## **FRAME STAGE INSPECTION REPORT AND DEFECTS LIST**

**Address of Subject Property:**  
Lot 55 Sample Pde, Sampleville

**Client:**  
Mr John Sample

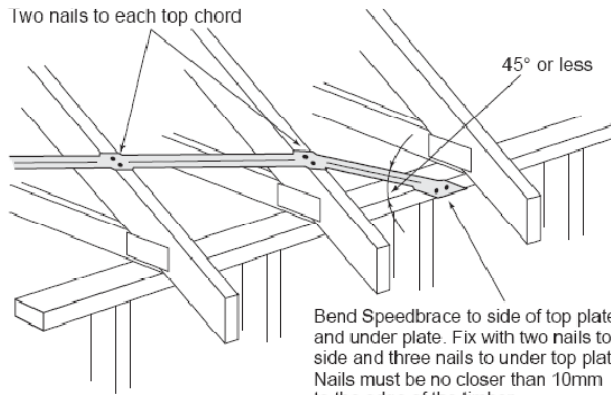
5.	<p>Framing Issues</p> <p>There have not been jamb studs installed to the ends of the lintels over most of the required window and doors openings throughout these Units.</p>  <p>It is a requirement of A.S 1684 Residential Timber-Framed Construction, clause 6.3.2.3 Jamb Studs (studs at sides of openings), that '<i>openings are to have 1 full-length stud on either side of the openings</i>'. Additional jamb studs will have to be installed to the required ends of these lintels.</p>

**Alternative Heel End Fixing Detail**

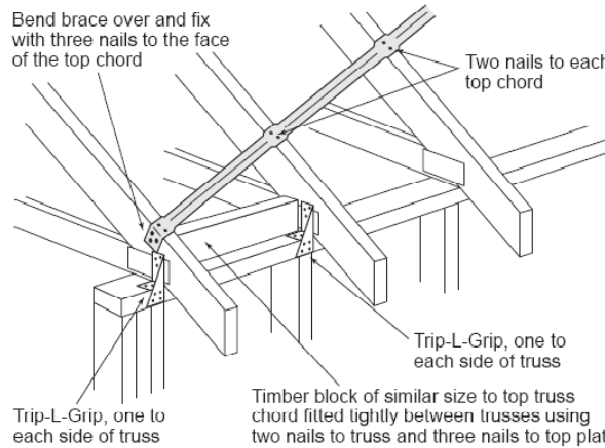
9.	<p>The diagonal speedbracing that runs across the tops of the trusses has not been fixed to the wall top plates correctly.</p>  <p>The manufacturer's installation guidelines state <i>'Bend the speedbrace to the side of the top plate and in under the plate. Fix with two nails to the side and three nails to under the plate. Nails must be no closer than 10mm to the edge of the timber. Shown below</i></p>

The fixing of the speed bracing must be rectified in accordance with the above, or if this method is not achievable then the alternative heel fixing detail must be used.
